# Access Compliance Report

## Public Rights-of-Way

Intersection ID: 26825	Main Street: OAK_POND_CR	Cross Street: SUMMERSTON_PL	Location: SW
ADA ID: A6F4E45503D7	Ramp Type: PerpDiag	Initial Pass/Fail: Fail	Overall Compliance: No
Severity Score: 37.5			
Codes/Mitigation Info/Possible Solution		Field Measurements/Component Compliance

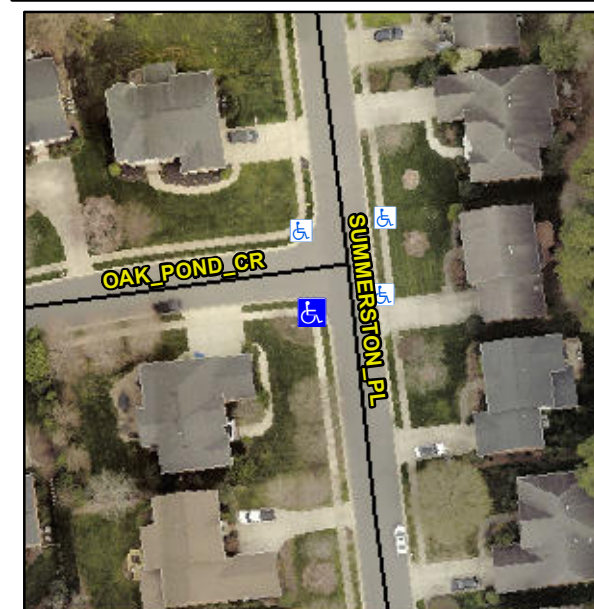
**R304.2.2, R304.5.3**

Compliance	Description	Data	Compliance	Description	Data
N/A	Ramp Length (in)	46.0	No	Ramp Slope (%)	10.5
Yes	Ramp Width (in)	97.5	No	Ramp XSlope (%)	8.4
N/A	Flare Type LT	N/A	N/A	Flare Type RT	N/A
N/A	Flare Slope LT (%)	N/A	N/A	Flare Slope RT (%)	N/A
N/A	Flare Traversable LT?	N/A	N/A	Flare Traversable RT?	N/A
N/A	Landing Length (in)	N/A	N/A	DWS Provided?	N/A
N/A	Landing Width (in)	N/A	N/A	DWS Contrast?	N/A
N/A	Landing Slope (%)	N/A	N/A	DWS Length (in)	N/A
N/A	Landing X Slope (%)	N/A	N/A	DWS Full Width?	N/A
N/A	Landing Curb? (Y/N)	N/A	N/A	DWS Offset (in)	N/A
N/A	Shared Landing?	N/A			
N/A	Gutter Ponding?	N/A	N/A	Gutter Slope (%)	N/A
N/A	Gutter Lip Ht (in)	N/A	N/A	Gutter X Slope (%)	N/A
N/A	Painted X Walk1?	No	N/A	Painted X Walk2?	No
	X Walk 1 Direction	To NE		X Walk 2 Direction	To N
N/A	X Walk 1 Width (in)	N/A	N/A	X Walk 2 Width (in)	N/A
	X Walk 1 Slope (%)	2.6		X Walk 2 Slope (%)	3.0
	X Walk 1 X Slope (%)	5.2		X Walk 2 X Slope (%)	2.7

N/A	Ramp inside XWalk1?	N/A	N/A	Ramp inside XWalk2?	N/A
	Road Slope (%)	6.6	N/A	Clear Space?	N/A
	Road X Slope (%)	1.8	N/A	Clear Space to XWalk (in)	N/A
N/A	Any Obstructions?	N/A	N/A	Storm Grate/Utility Hazard?	N/A
	Obstruction Type			Storm Grate/Utility Type	
		N/A			N/A
		Yes		Surface Condition? (G/P)	Good

**Remove & Replace Curb Ramp With Two New Directional Ramps or Equivalent.**
